Response to Comments
Montana Department of Environmental Quality Waste Management and
Remediation Division
MPDES Permit MT0032247

Responses to Comments on the Fact Sheet and Draft MPDES Permit MT0032247

Figure 1

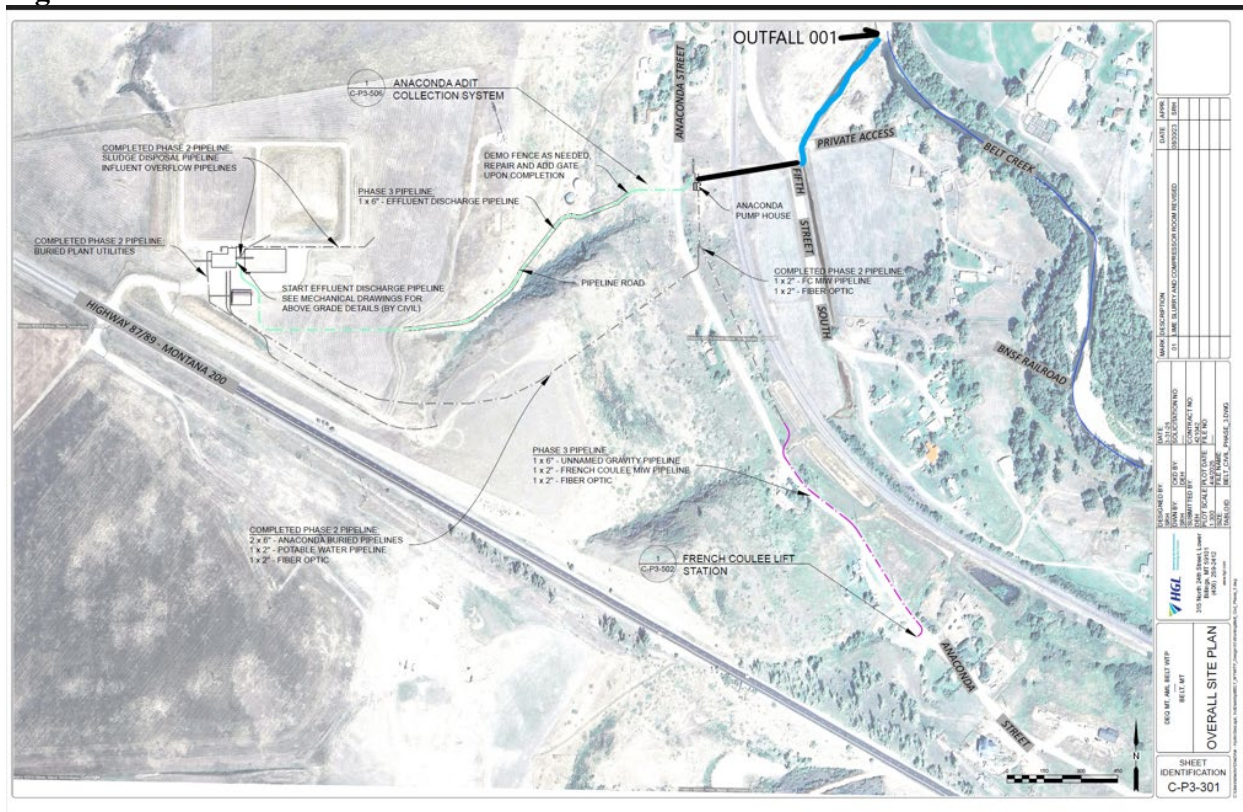
Comment 1: The map included in the posting was not updated. The new discharge path does not flow on the surface. The treated water will be placed in a pipe and will parallel the influent pipe. The text is correct, and the treated water will flow through a pipe back to Belt Creek. The updated flow path is on the attached map.

Comment 2: The Permit and Fact Sheet (FS) should clarify details about the receiving water and outfall/monitoring location. After reading through the FS and draft Permit, the route by which the discharge reaches the receiving stream (and some details about the receiving stream itself) are unclear. For example, page 5 of the FS states that the discharge pipeline ties into an existing Anaconda MIW discharge pipeline, which discharges to Belt Creek. Page 6 states that discharge to Belt Creek is via an unnamed natural dry drainage. Page 7 states that effluent monitoring shall occur either at the point of discharge to the unnamed dry drainage, or where the effluent is pumped from the WTP into the discharge pipe. Page 8 states that there are three receiving waters (but does not identify them). The Permit (page 1) states that the receiving stream is Belt Creek, and (page 3) states the outfall is a pipe discharging into Belt Creek, but gives a latitude/longitude that is approximately 0.75 miles from Belt Creek. After reading through all of this and looking at Figure 1, it is unclear whether there is some kind of existing underground piping network leading from the facility directly to Belt Creek, or if the discharge is to an unnamed tributary to Belt Creek. The concern is that there could be some confusion on where the actual monitoring location should be. The EPA recommends that MDEQ further clarify what the actual receiving stream is, whether the discharge enters Belt Creek from a pipe or from an unnamed tributary, and ensures that the description of the discharge monitoring location matches the coordinates.

Response: The map attached to the comment, reflecting the correct flow path for the buried effluent pipe and discharge location, is added to the administrative record. See also the response to comment 2 for additional clarification.

The underground effluent pipeline will follow the light blue/green line and the black line in Figure 1 below. The effluent pipeline is buried for its entire length and does not enter the Anaconda Pump House.

The effluent pipeline discharges to the existing Coke Oven Flats ditch near the intersection of Fifth Street South and the "Private Access" road (Figure 1). Coke Oven Flats ditch is the historic conveyance to Belt Creek for the Anaconda and French Coulee acid mine drainage.

The facility's treated effluent will flow in the Coke Oven Flats ditch (blue line) and discharge to Belt Creek at the location labeled Outfall 001 in Figure 1. Outfall 001 is located at Latitude 47.38240, Longitude -110.92792.

The permit has been edited to reflect the immediate receiving water of Coke Oven Flats Ditch.
